ADDENDUM

No. 03 Date: 9/11/2024
Project No. 0020711.01 Attention: Leonard D'Souza
Project Name: Princess Margaret Cancer Centre
Stem Cell Transplant 2, MHC, MHDU, DSC
Address: University Health Network
610 University Avenue
Toronto ON

This Addendum forms a part of the Bidding and Contract Documents and modifies the original issued Bidding Documents (dated August 13, 2024) for the above titled project, as indicated below, and is hereby incorporated into the Contract Documents as part thereof.

3 LEVEL 06 - CONSTRUCTION CONTROL PLAN
1:300

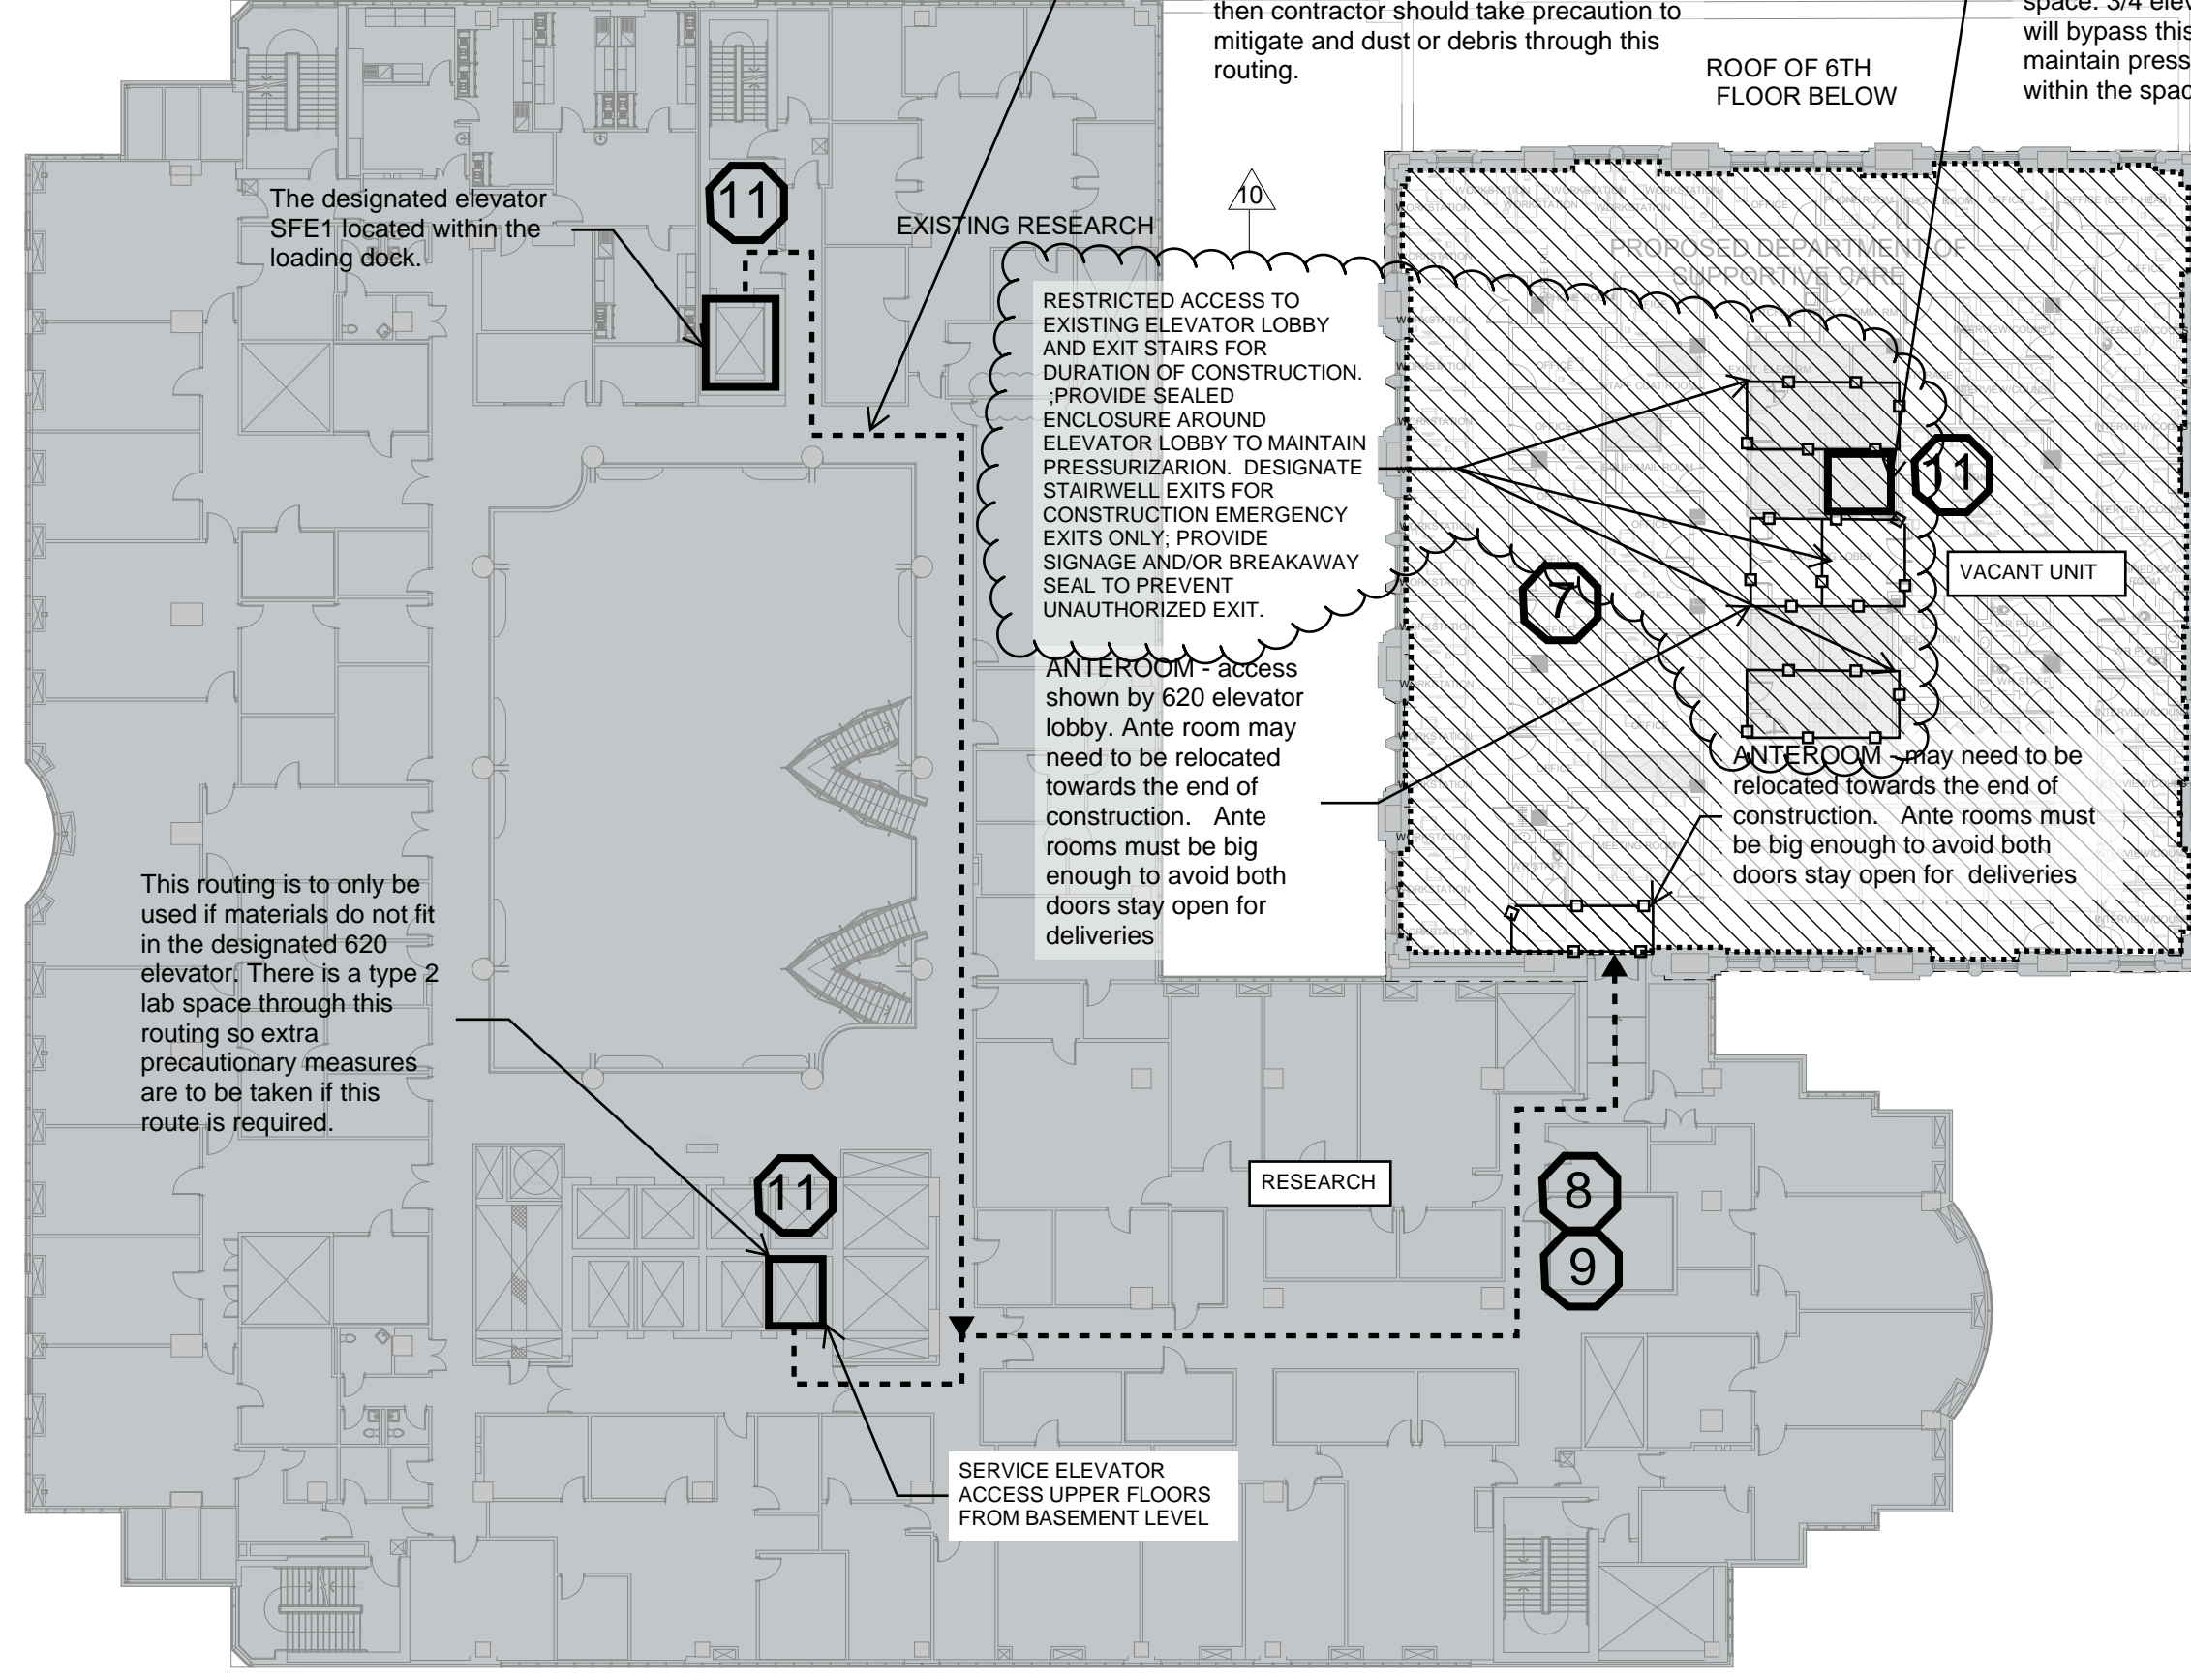
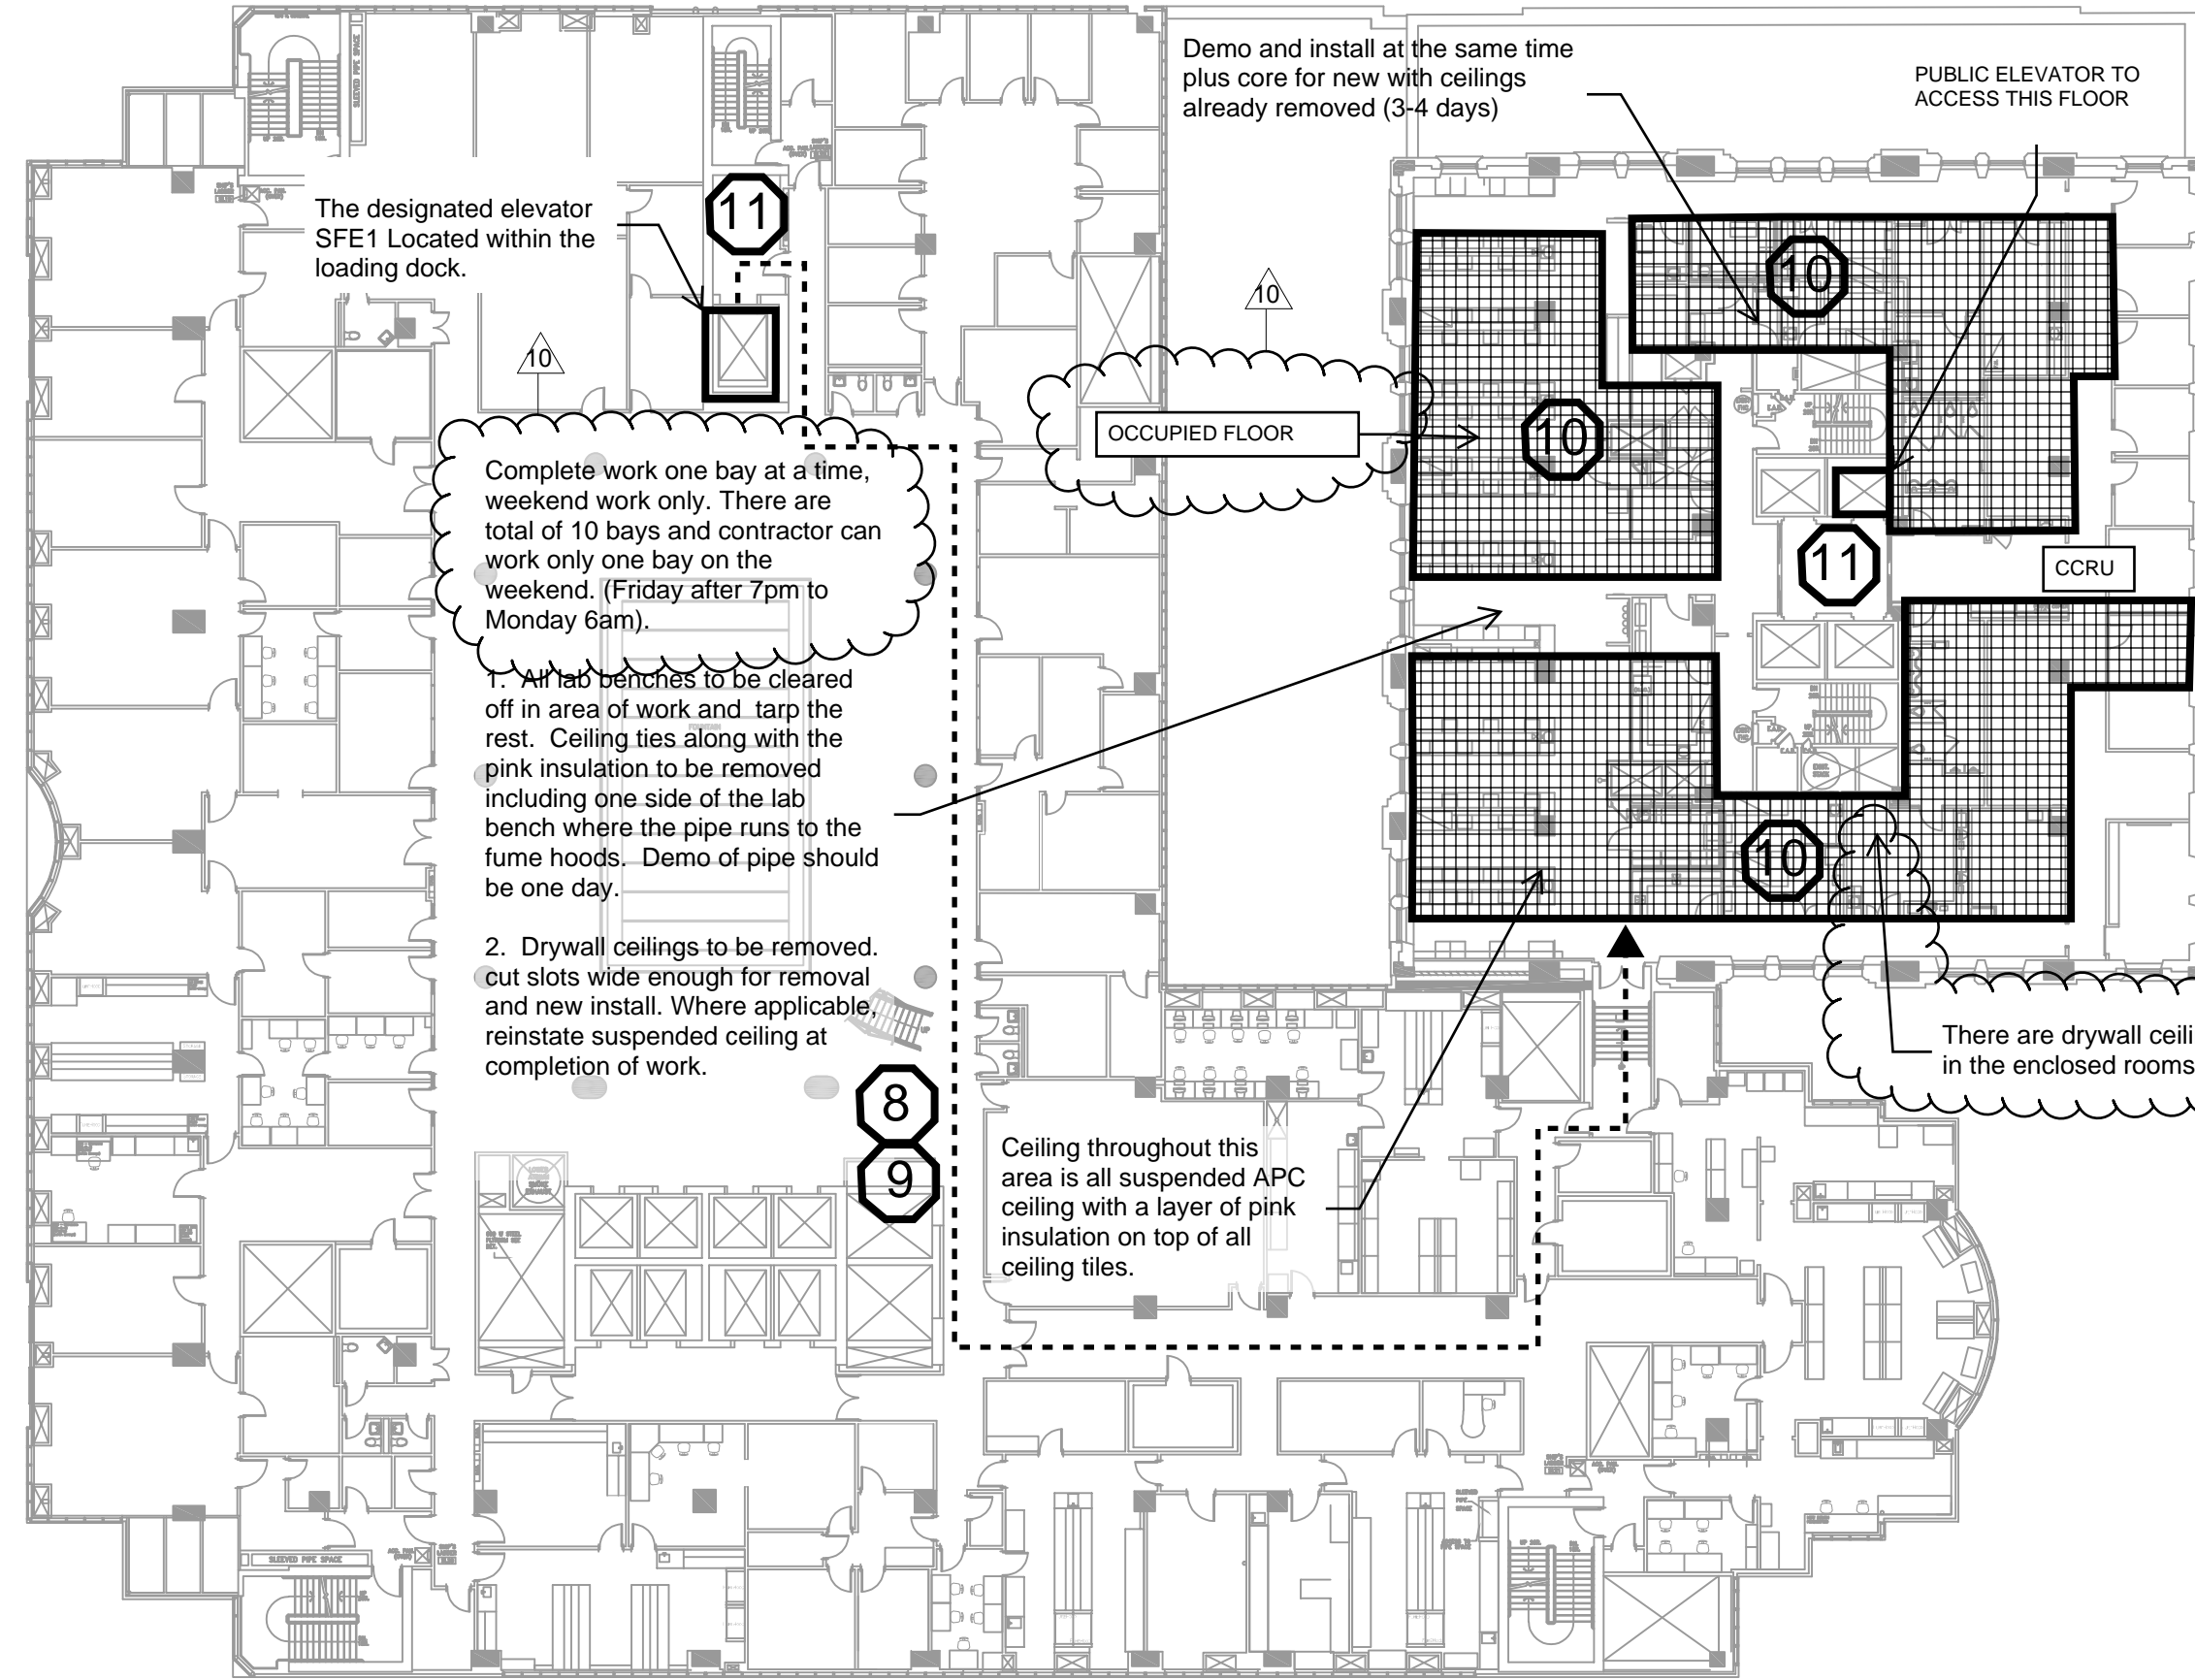
DRAWING G0502 – CONSTRUCTION CONTROL PLANS

Revised legend, added notes for exit stairs, ceiling types, limitation on Level 9 work, occupancy of the floor.
